N3381A-01C

SERVICE NOTE

Supersedes: N3381A-01B

N3381A PNA Series RF Network Analyzers

Figure 1

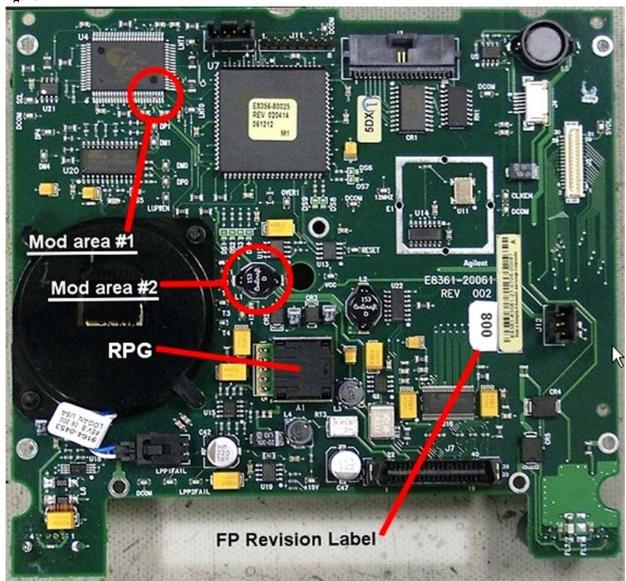
Refer to Figure 1 for the two modification areas to be addressed. Note that while this picture happens to show the FPI board completely removed from the front frame assembly, this is not necessary to perform the required modifications.

- . Modification #1 consists of shorting two pins of U4 together with a small amount of solder.
- Modification #2 consist of removing L1.

Figure 2

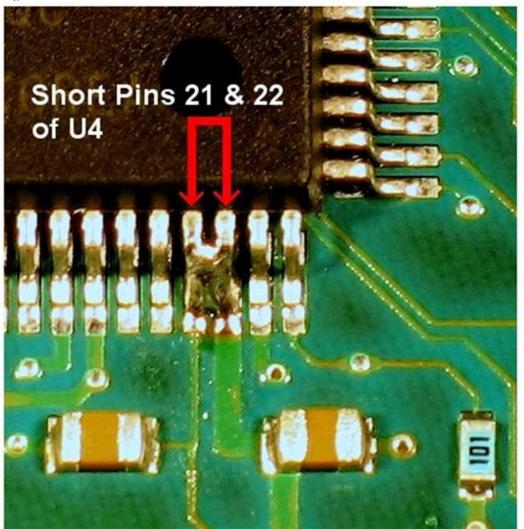
Carefully solder pins 21 and 22 together on U4. Refer to Figure 2 for the exact location. Use care so that no other pins are shorted. Use of a very fine tip soldering iron is recommended and a large work-task magnifying glass is very helpful.

Unsolder and completely remove the black surface mount inductor L1 from the front panel assembly board. This is no longer needed and can be discarded.
